CITY OF ALBUQUERQUE

RE: Utility Trailer Sales
8201 Daytona Rd NW
Grading Plan Stamp Date: 5/14/18
Drainage Report Stamp Date: 5/14/18
Hydrology File: K09D026B

**RE: Utility Trailer Sales
8201 Daytona Rd NW
Grading Plan Stamp Date: 4/30/18
Drainage Report Stamp Date: 4/30/18
Hydrology File: K09D026B**

<p>ENGINEER'S SEAL</p>	<p>UTILITY TRAILER SALES ALBUQUERQUE NM</p>	<p>DRAWN BY LA</p>
	<p>CONCEPTUAL GRADING AND DRAINAGE PLAN</p>	<p>DATE 05/23/20118</p>
<p>VINCENT P. CARRICA P.E. #16212</p>	 <p>TIERRA WEST, LLC 5571 MIDWAY PARK PLACE NE ALBUQUERQUE, NM 87109 (505) 858-3100 www.tierrowestllc.com</p>	<p>2017041-GRADING 2</p>
		<p>SHEET # C2</p>
		<p>JOB # 2017041</p>

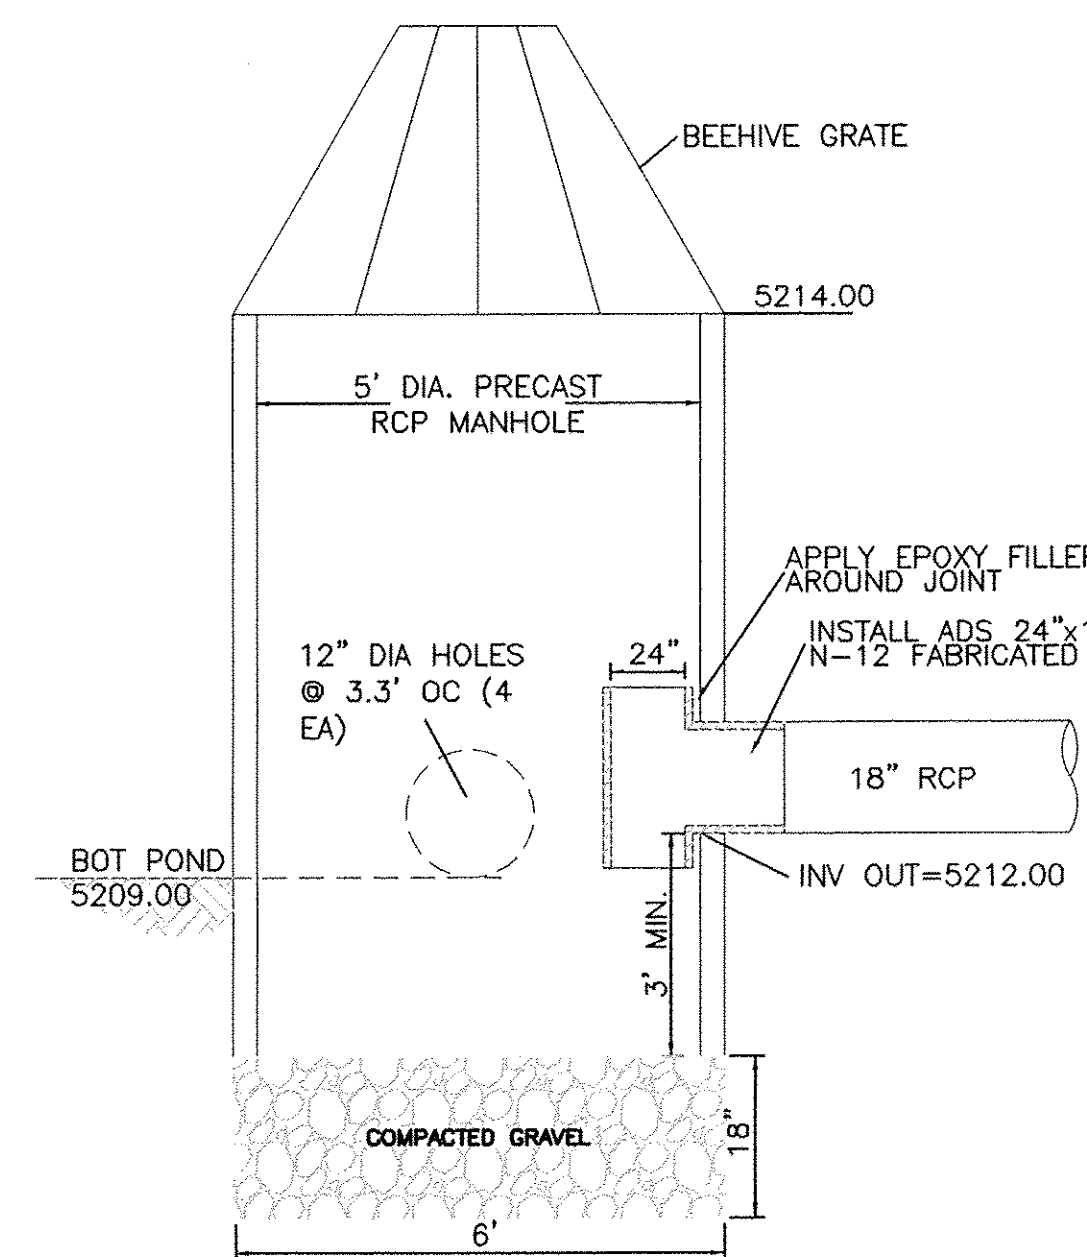
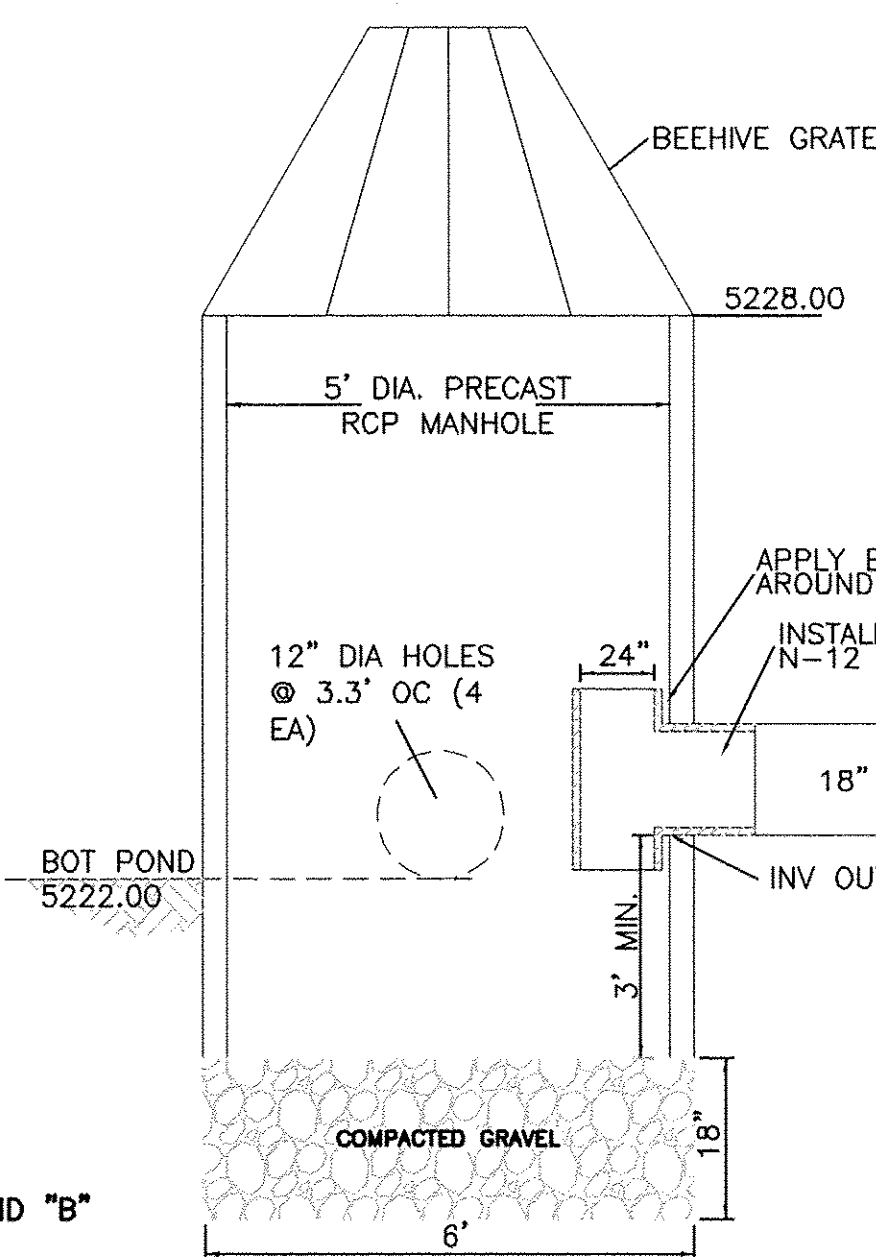
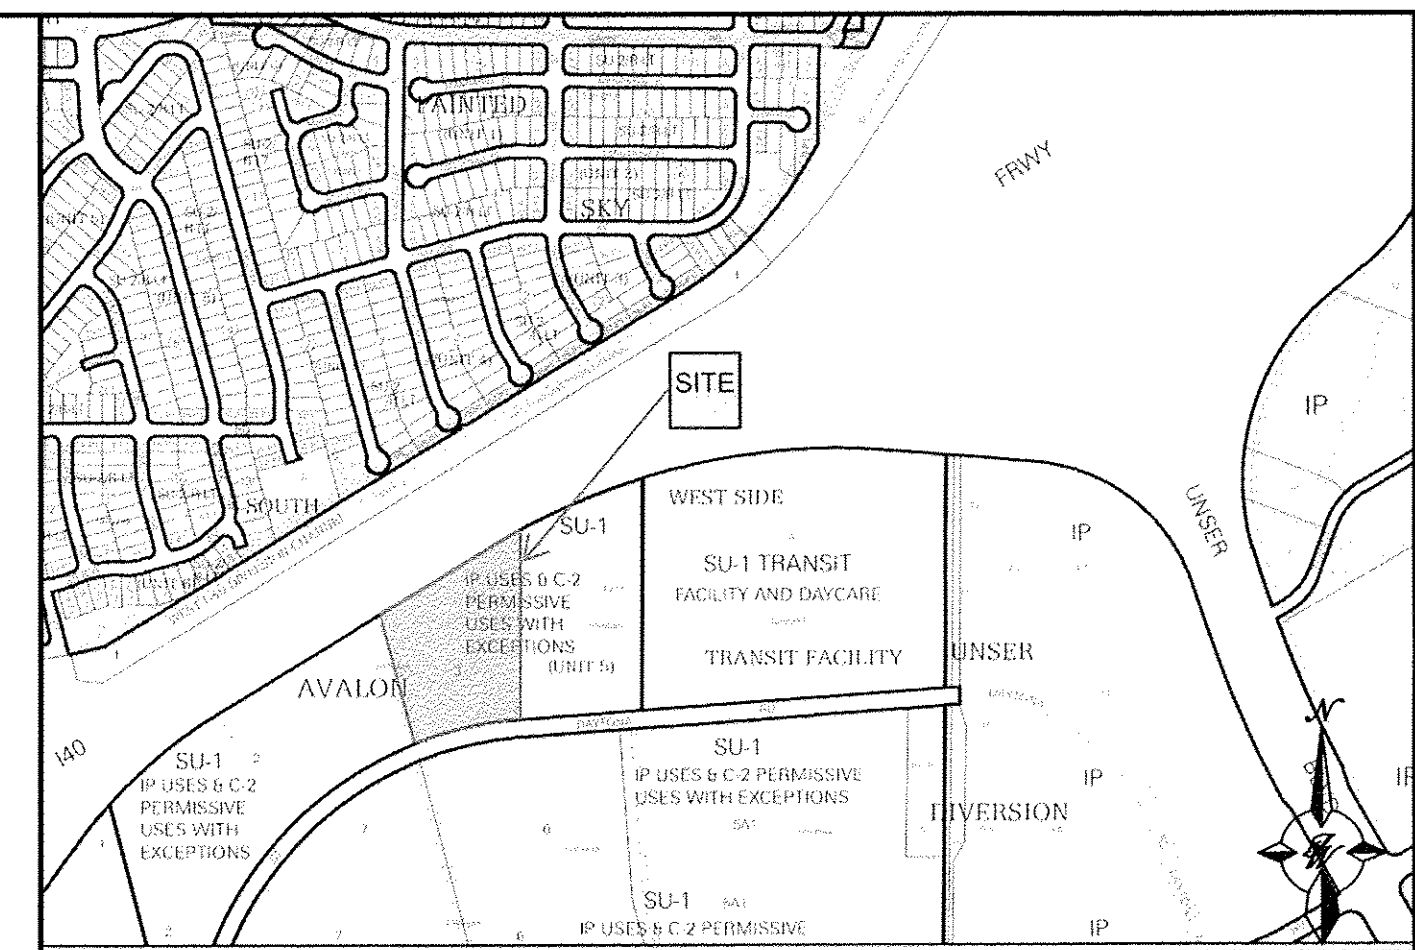
1. Label the grading plan as “Conceptual, not for Construction” or similar. This will be checked at DRB.
2. The pond and swale with an Agreement and Covenant and a Public Drainage Easement on Tract2 need to be included on the infrastructure list.
3. The Public Drainage Easement and the Agreement and Covenant on the NE corner of Tract3 need to be included on the infrastructure list.

4. The grading in the SE corner of the site does not support the proposed drainage pattern. For instance the contours and spot elevations do not indicate a swale along the property line, connecting the two first flush ponds. The SE corner is lower than the InvertOut of the adjoining pond riser (5012.00' vs ~5010.20'-5011.00'). The grading in this area will need to be reworked to ensure a clear flow path from Pond A to Pond B to the 18" RCP into Daytona. Pond B bottom and InvertOut will likely need to be lowered.
5. There are a few proposed spot elevations and contours across the property line onto Bruckner's property. Please correct to show no grading across the property line here. If this work is required, written and signed permission will need to be obtained from the property owner.

1. There may be a need for additional inlets in Daytona to contain future developed flows in the street. Provide street capacity analysis in Daytona. You may assume the subject site as discharging directly into the storm drain as you've proposed; however the upstream contributing basins will need to be assumed as discharging to the street.

2. Include inlet protection for the two new RCP stubouts to keep floatables and sediment from washing into the storm drain (ported riser or similar).
Response: Water quality manholes/ported risers were added to the RCP outfall pipes from the proposed ponds.

4. Provide a public drainage easement and an agreement and covenant for the riprap and gabions in the NE corner.

5. Include project datum.

6. This grading plan includes existing and proposed contours and spot elevations showing regrading of the I-40 bar ditch and grading at both median drain outfalls. Provide written concurrence from NMDOT D# Drainage that this project can proceed. All work in NMDOT's ROW will need to be included on the infrastructure list.

Response: Analysis Point AP-1.1 of the I-40 South Unser Mini DMP (K09D026) shows a flow rate at the subject site's SE corner equal to 66.5 cfs. Deducting the 17.37 cfs runoff on this site from that flow rate leaves 49.13 cfs for the upland flows to the west that would be contributing to flow in Daytona Rd. A 36" storm drain is proposed to be constructed through the frontage of the subject property to the west end of Daytona. The storm drain is shown to have a capacity of 78.56 cfs, which can handle the upland flows of 49.13 cfs. The Daytona roadway also has a minimum capacity of 52.41 cfs at the proposed 3.81%. Roadway capacity calculation sheets have been added to the report.

Response: A site bench mark is included on the grading plan and the tie information back to the local AGRS monument has been added.

Response: As previously stated, no grading will be performed in the I-40 right of way. The previous plan incorrectly showed a change in the contours (existing to proposed). This has been corrected on the current plan.

UTILITY TRAILER SALES
DRAINAGE BASIN MAP
(DEVELOPED)

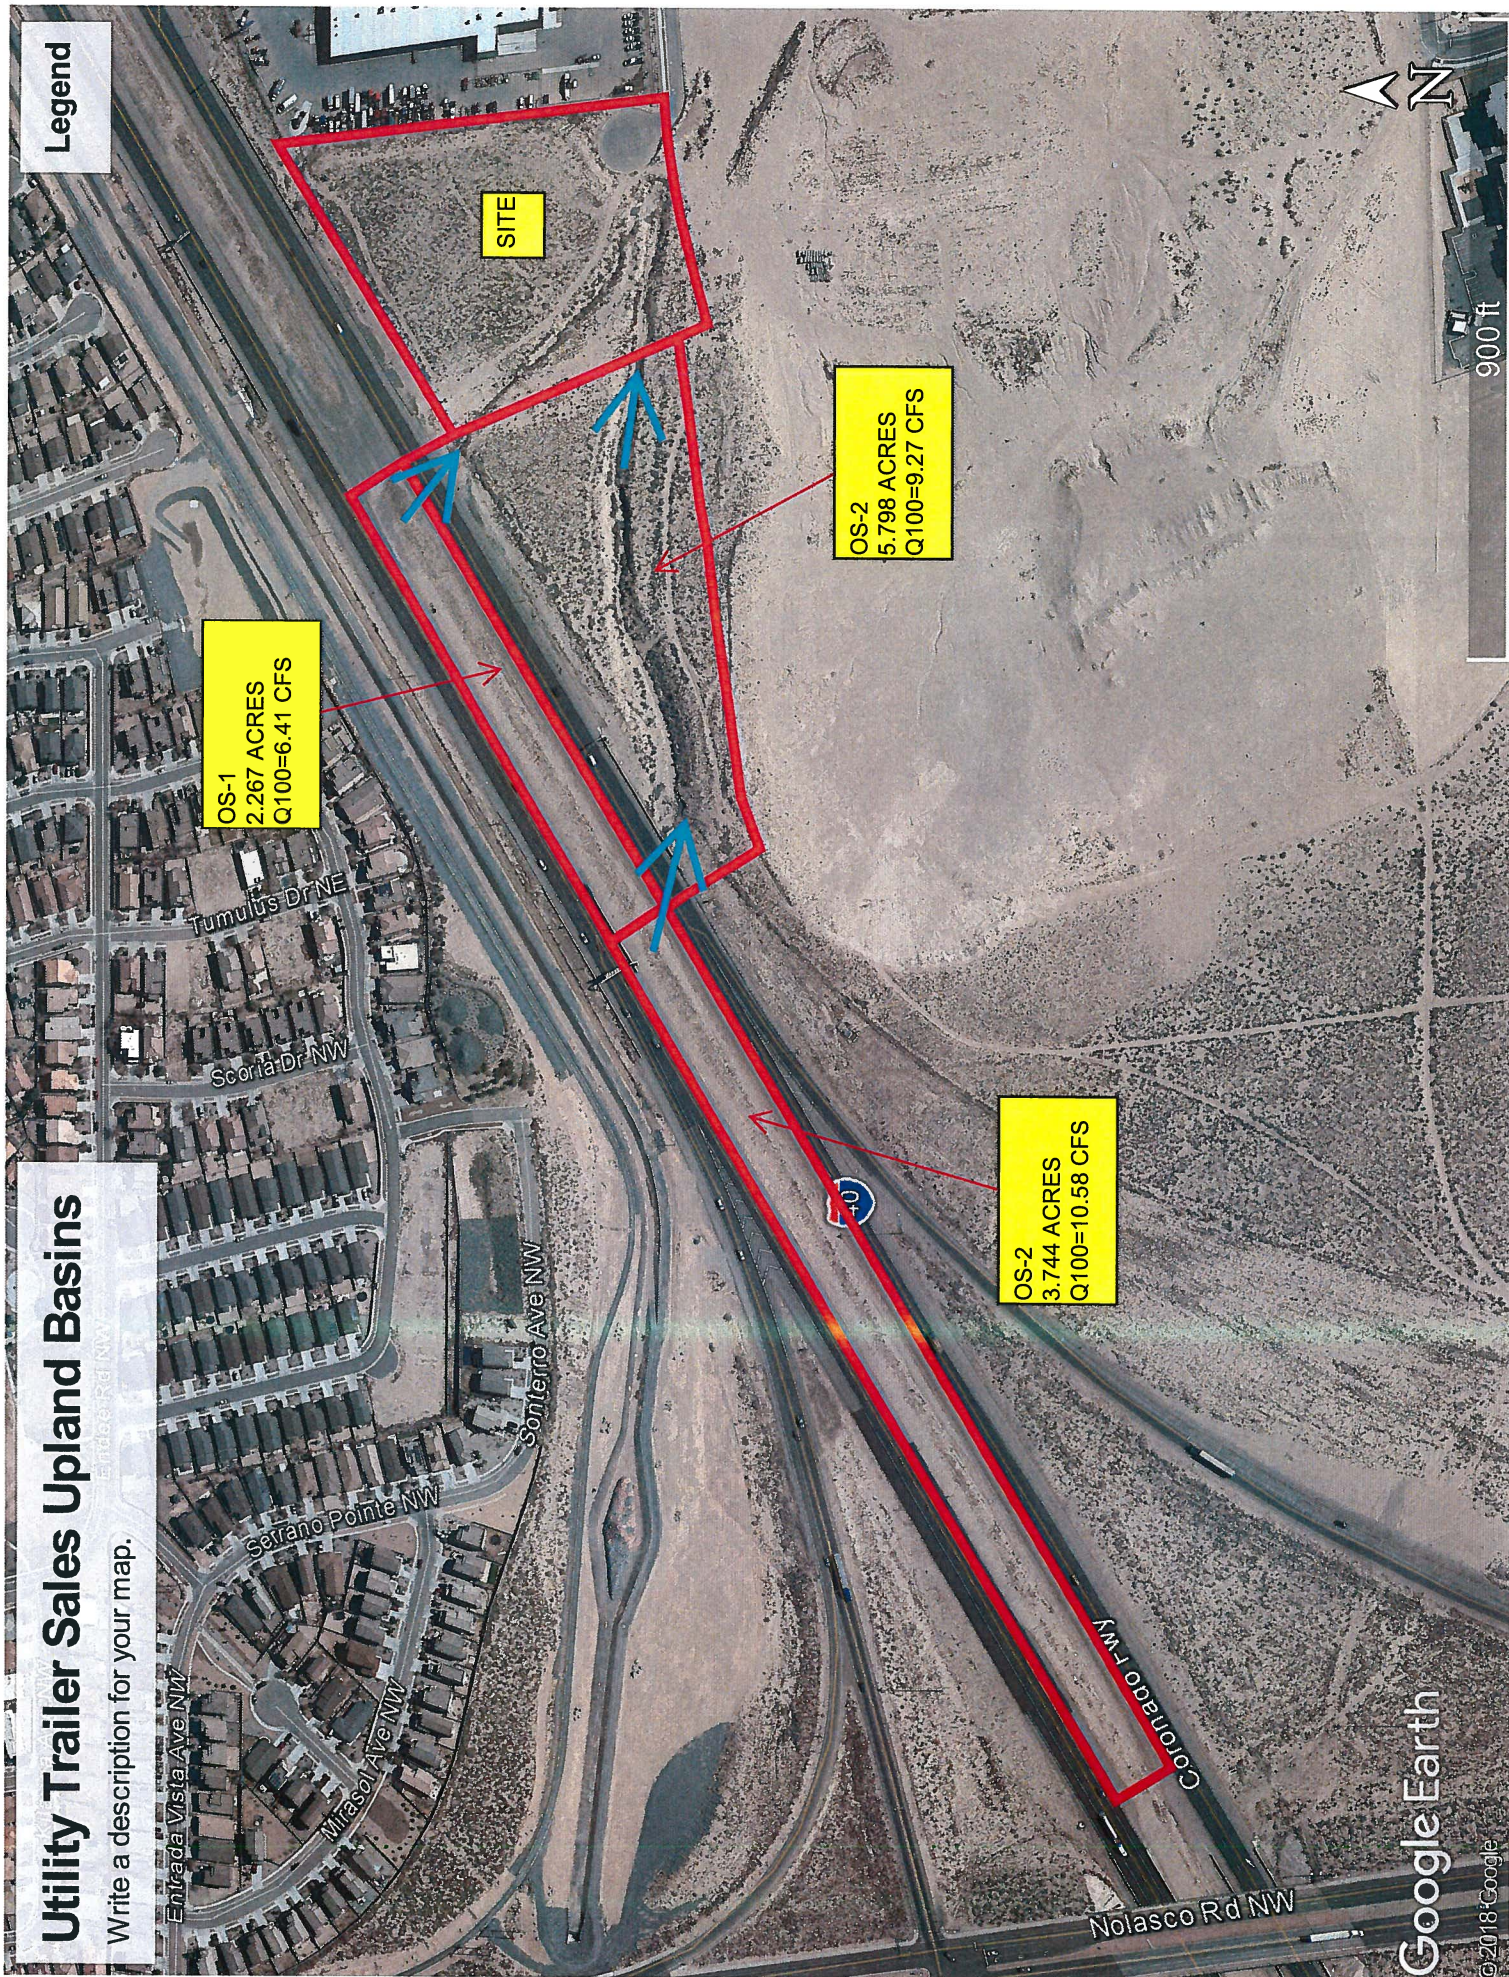
7. The upstream offsite basins need to be delineated and included in your analysis. Demonstrate that the diversion swales are adequately sized to convey these flows from the I-40 ROW to the receiving storm drain along Daytona.

Response: An upstream offsite basin Exhibit has been added to the report along with a calculation of the available capacity of the proposed drainage swale and its adequacy to convey the flows is shown.
